# Ugum Water Treatment Plant Rehabilitation GWA Project No. W22-10-BND IFB-05-ENG-2023 RFI Response No. 3 to Contractor Inquiries

2g.

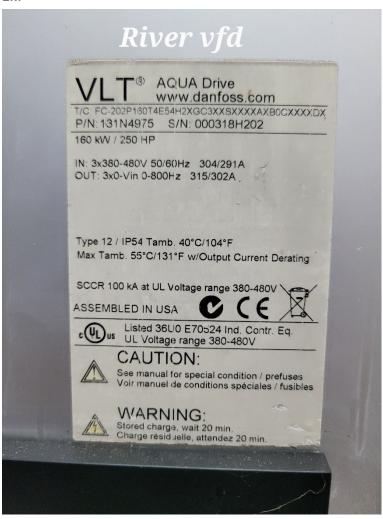
1	River Intake	3. Please provide overall length of the turbine pump including pump columns and/or pit depth.	3. Refer to pump dimensions on page 8.
		4. Please provide photo of the pump and motor data plates.	4. See response to Item no. 2 above.

2h.

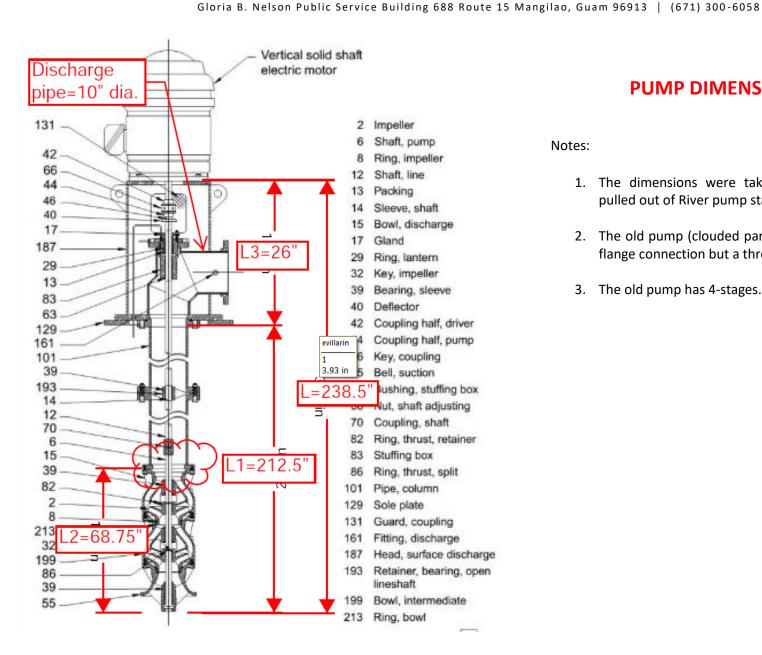
NO.	REFERENCE	QUESTIONS/INQUIRIES AS SUBMITTED	GWA RESPONSE	
Questions from January 23, 2023				
1	River Intake	Please confirm if they are replacing 2 out of 3 line shaft turbines to match the existing.	2 out of 3 pumps will be replaced. Pump "to match existing or equal in quality and performance" would be acceptable.	
		2. Please provide serial numbers of the existing pumps need to be replaced.	2. See attachment for photos of:	
			a. Backwash Pump-Motor Data Plate	
			b. Neutralization Tank Pump-Motor Data Plate	
			c. New River Pump Data Plate	
			d. New River Pump Motor Data Plate	
			e. Old River Pump Data Plate	
			f. Old River Pump Motor Data Plate 1	
			g. Old River Pump Motor Data Plate 2	
			h. River Water Pump – VFD
